## ADDENDA NO. 2

- A. Project Name: **Orange High School Phase 2 Renovations.**
- B. Owner: **Orange County Schools.**
- C. Architect: **CRA Associates, Inc.**
- D. Architect Project Number: **2231-OHS.2.**
- E. Date of Addendum: **January 24, 2025.**

sheet  
**A2.4**

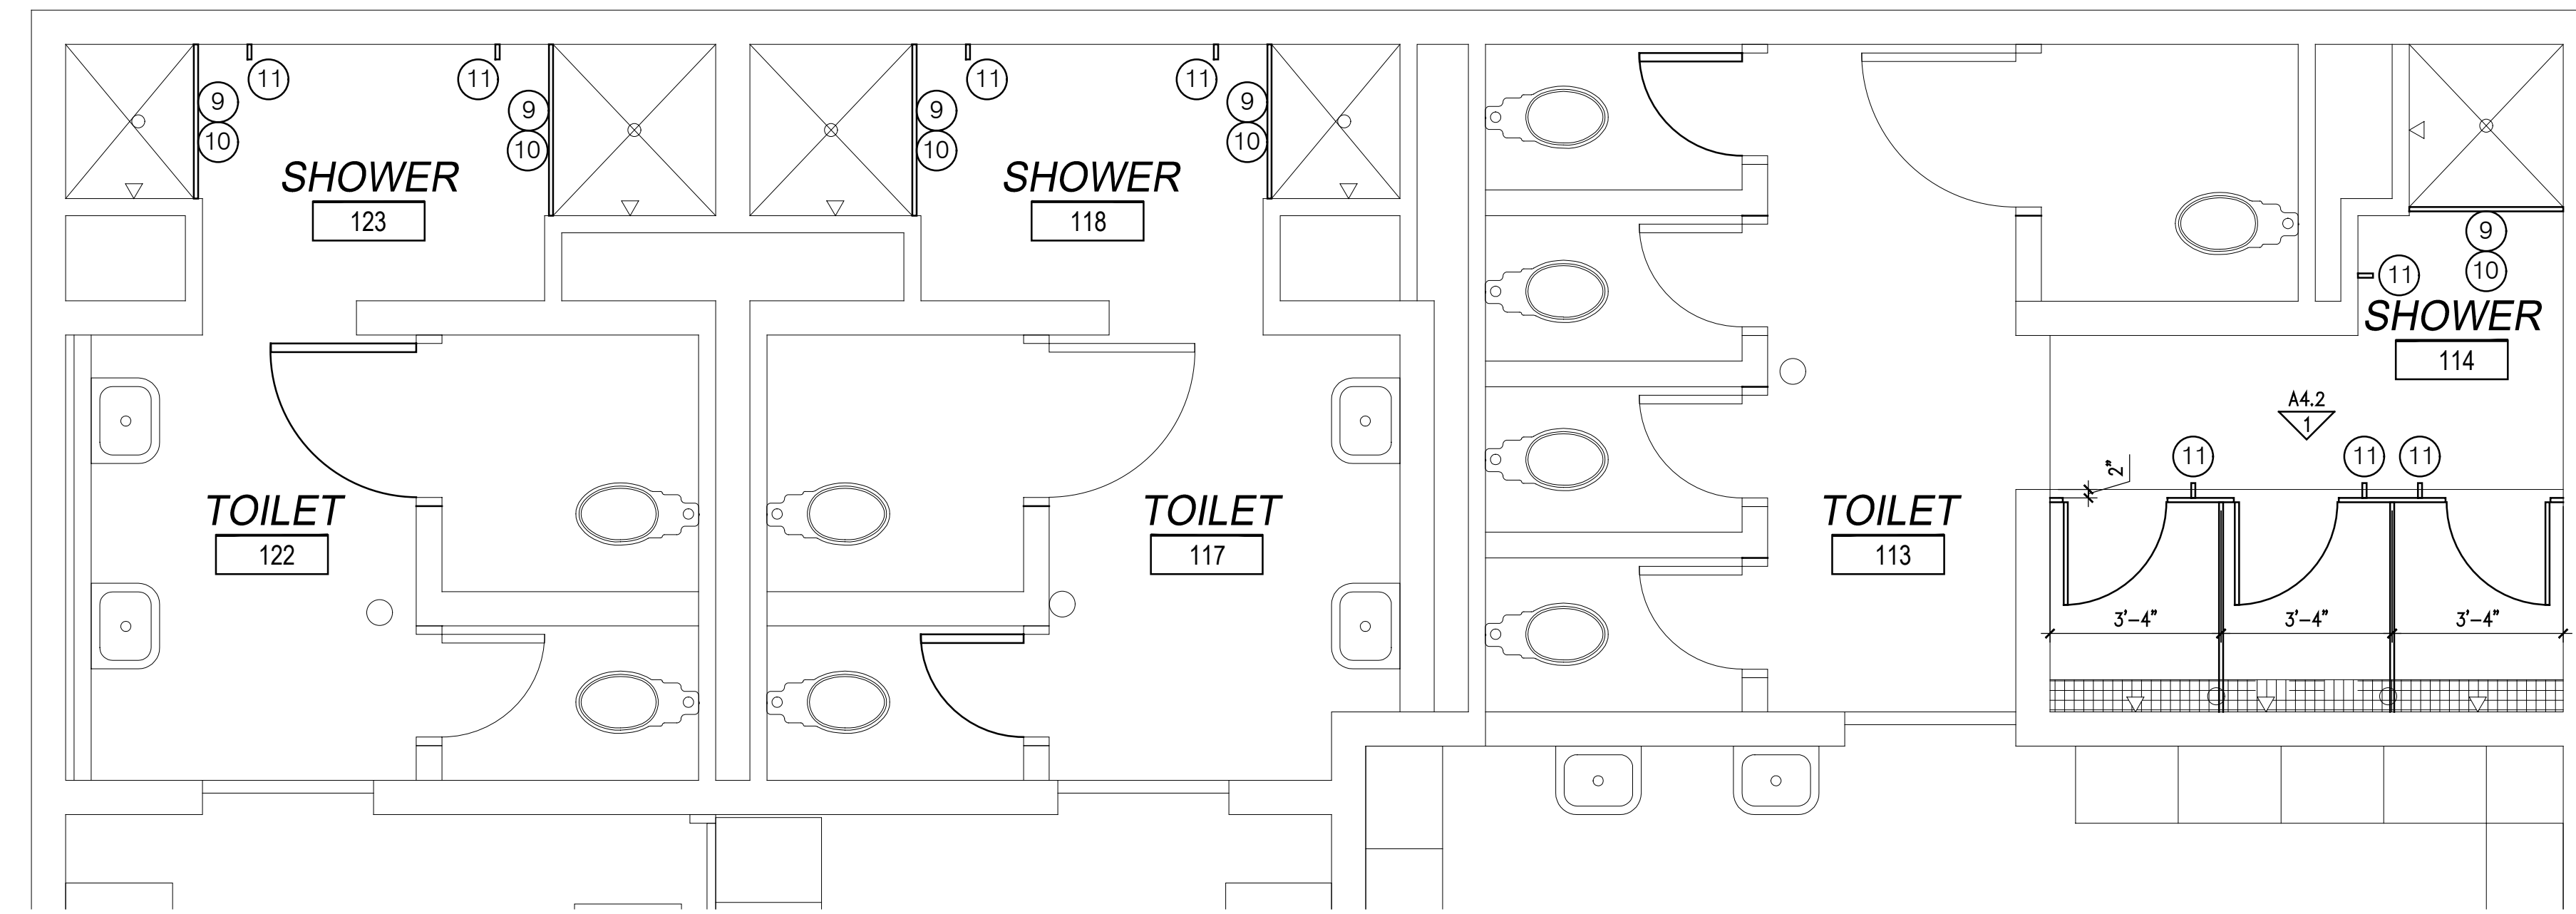
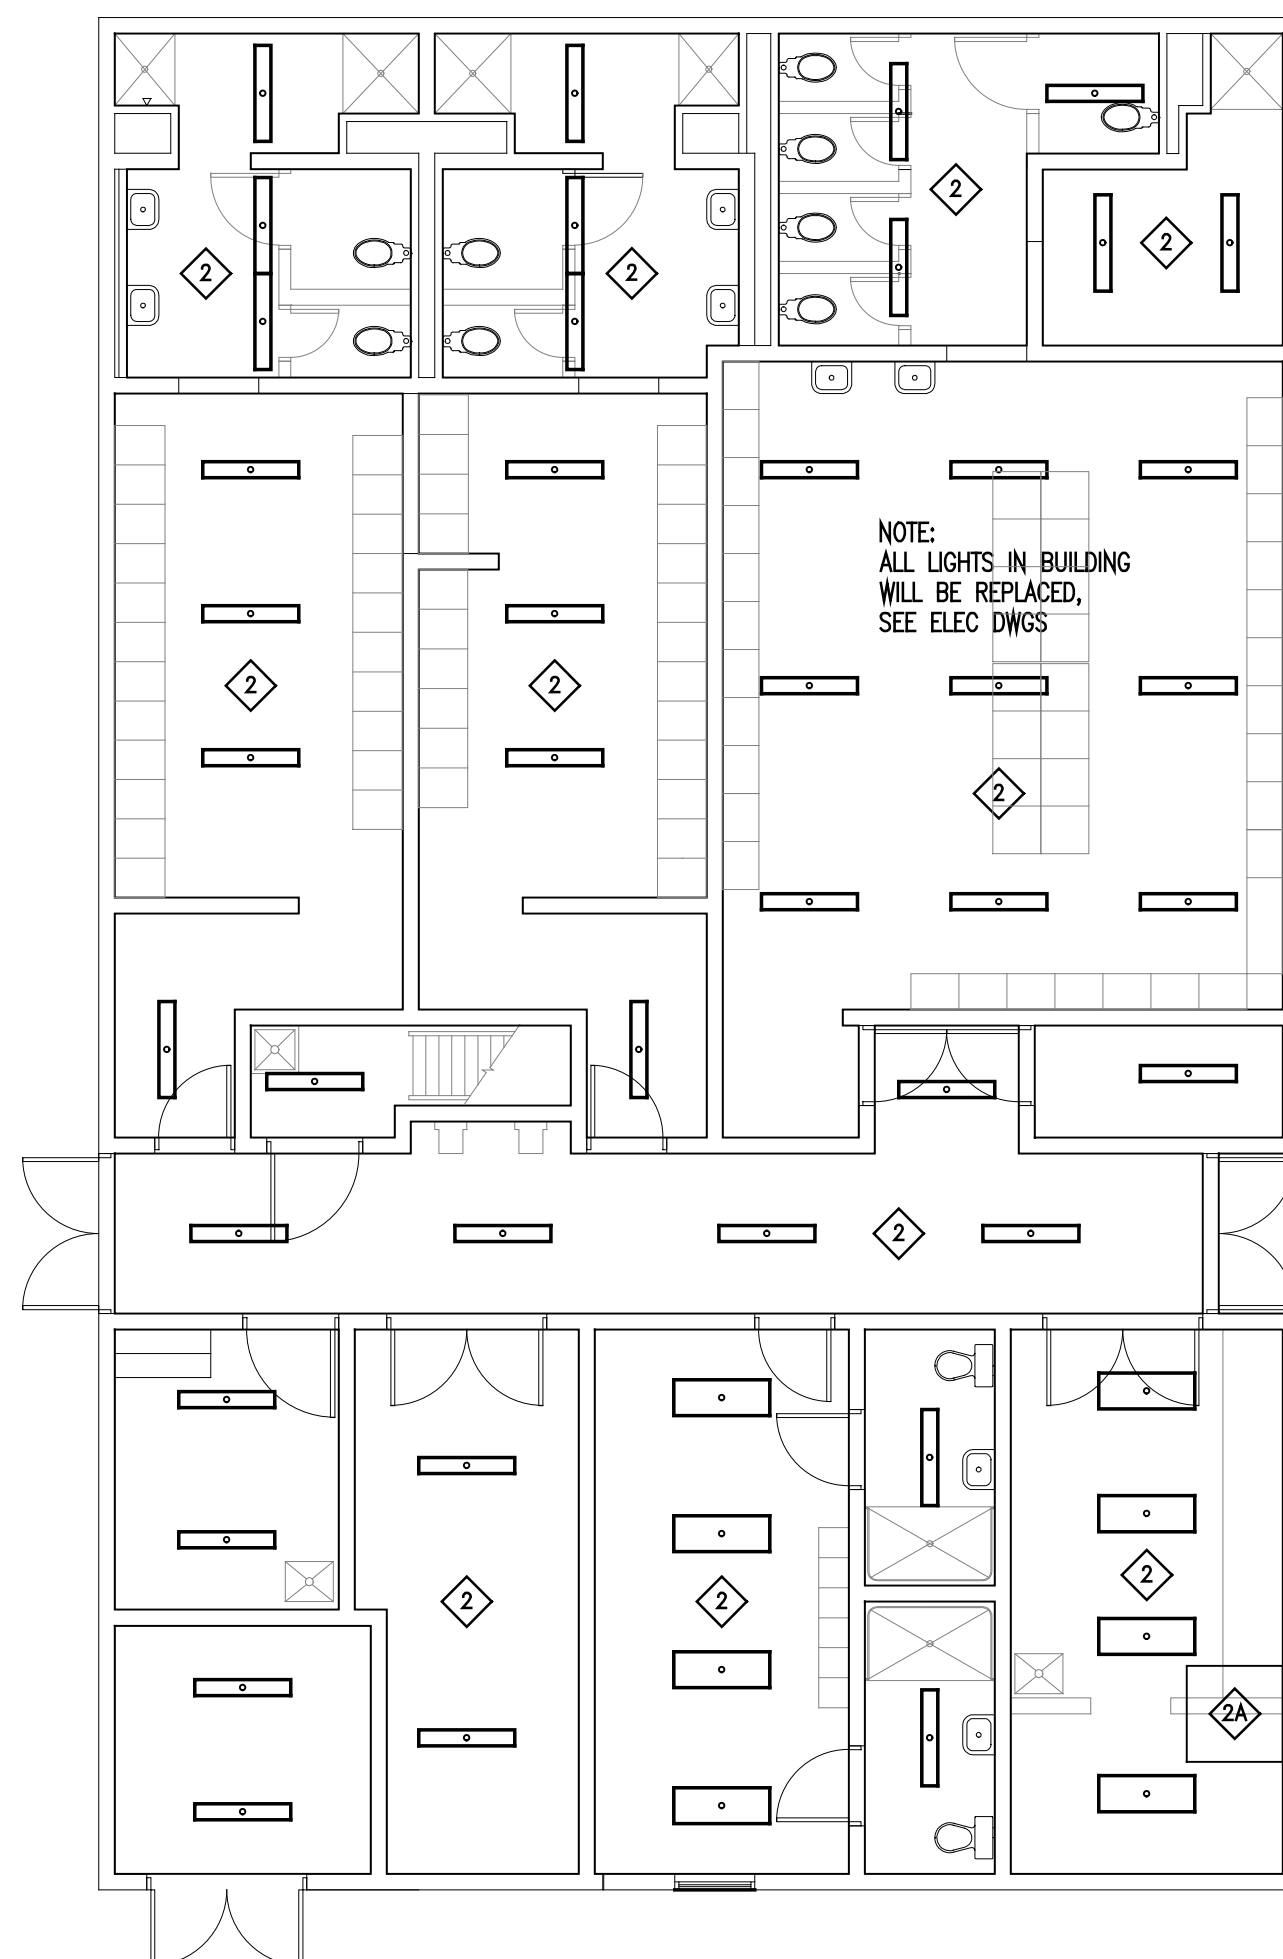
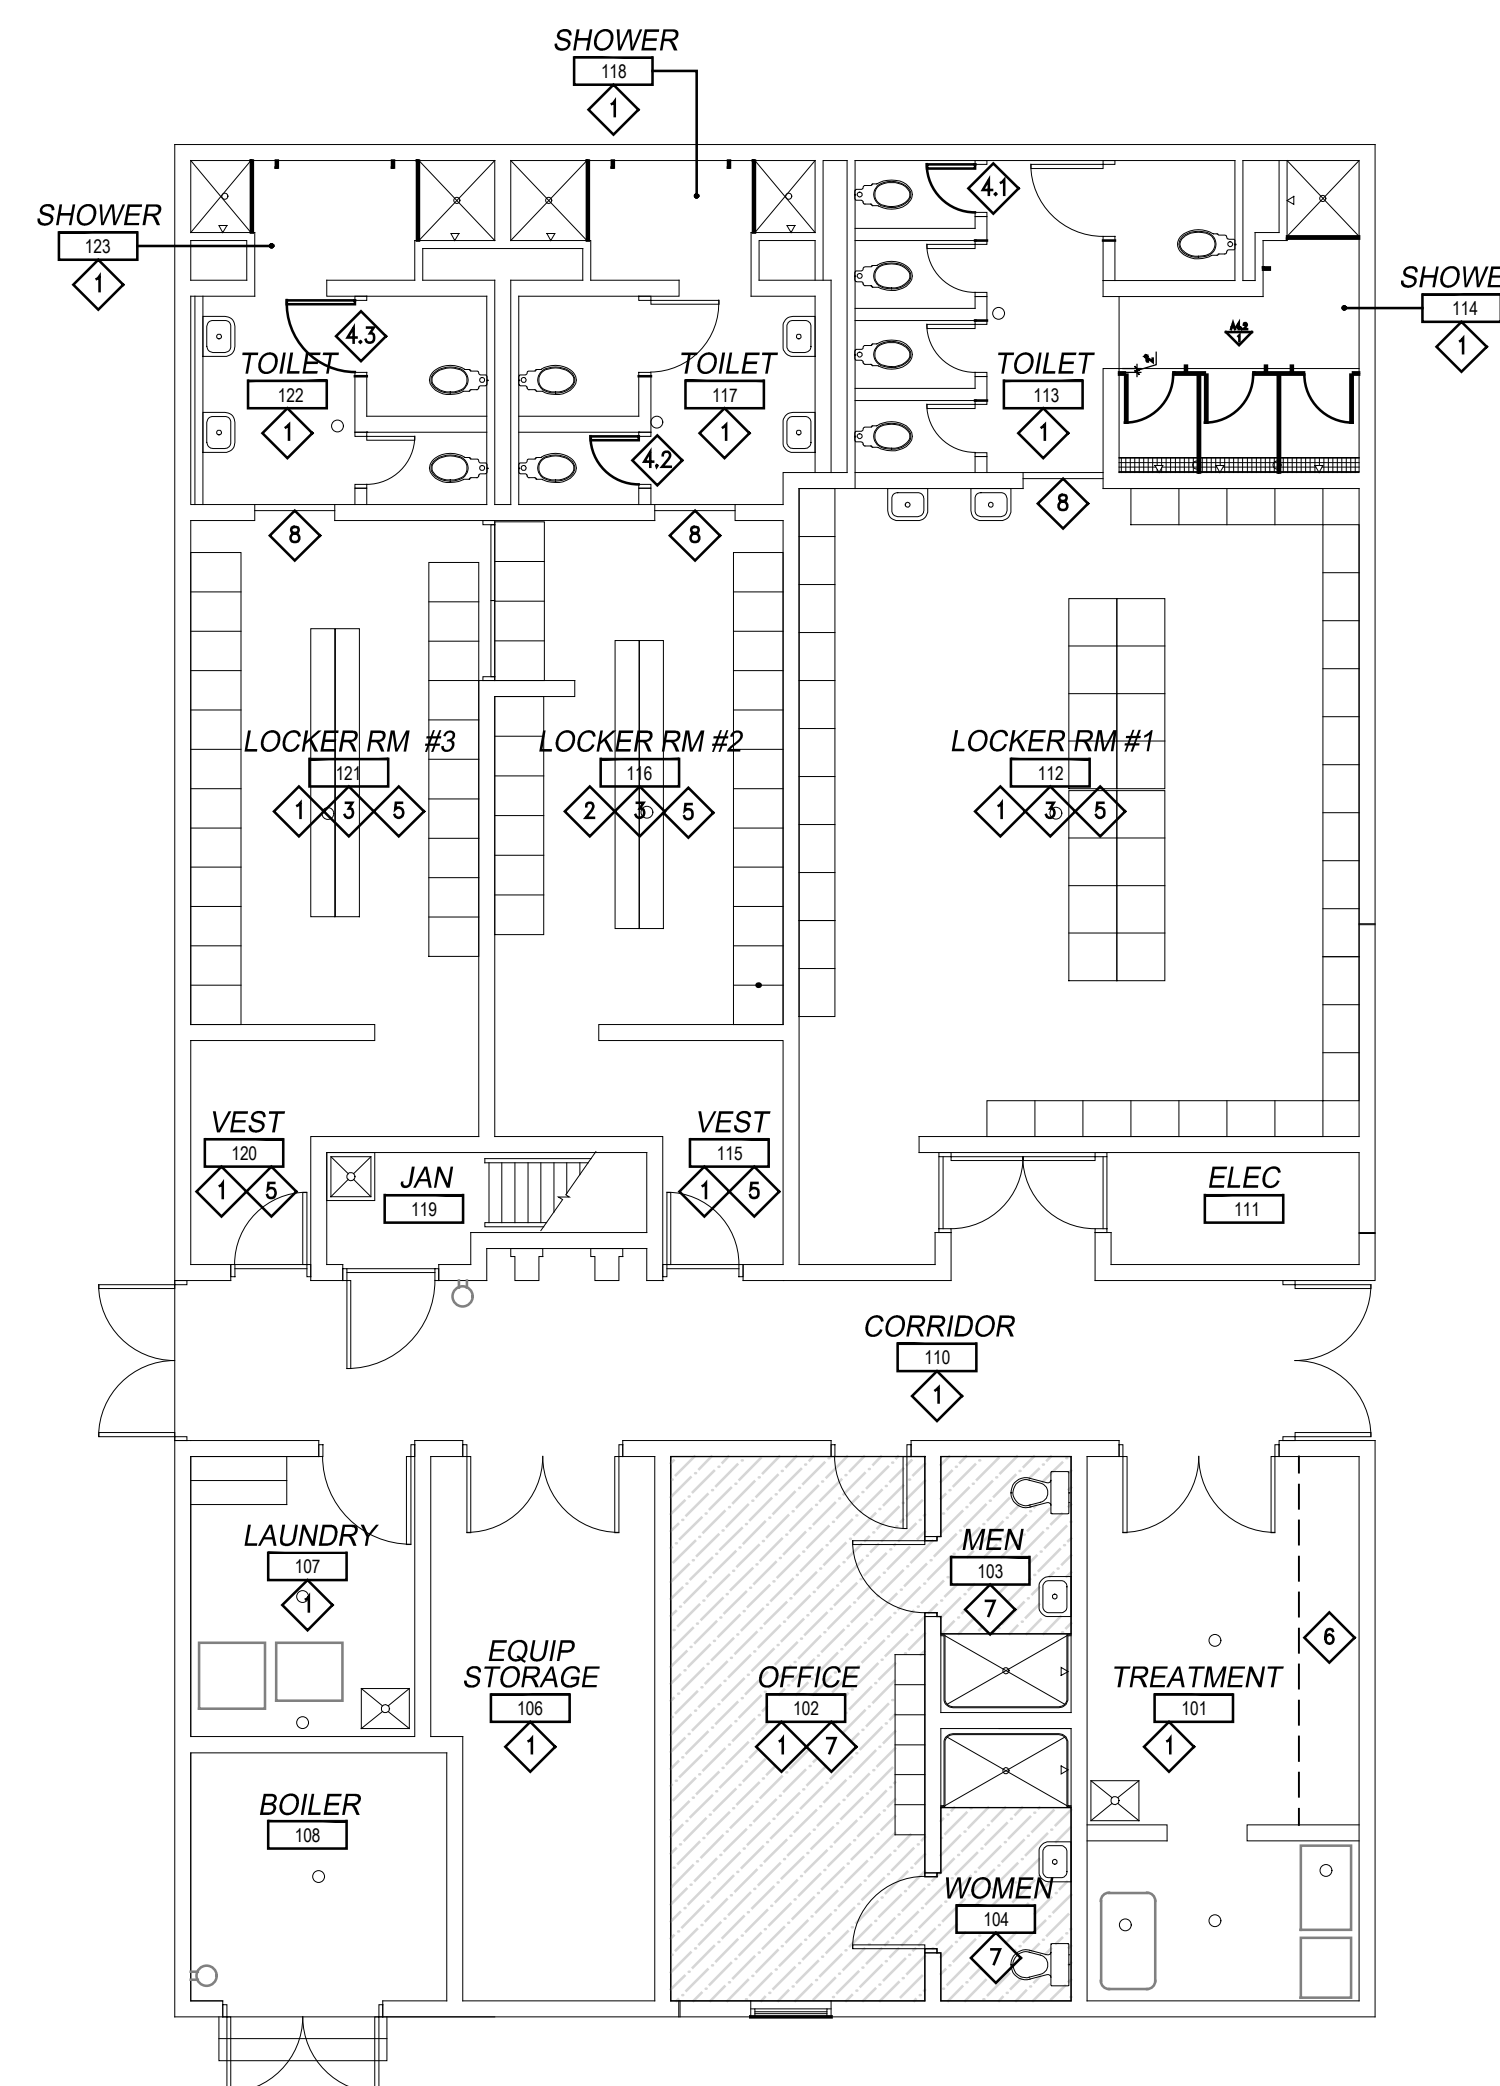
- A. This Addendum includes the following attached Documents and Specification Sections:
  - 1. Document “Form of Proposal,” (reissued).
    - a. Bidders are to use this Form in place of the Form included in the Project Manual and are reminded that it shall be accompanied by the attachments stipulated in the “Form of Proposal” and the “Notice to Bidders.”
- B. This Addendum includes the following attached Sheets:
  - 1. Architectural Sheet A2.4 – Field House Demolition and Renovation Plans, dated January 9, 2025, (reissued).
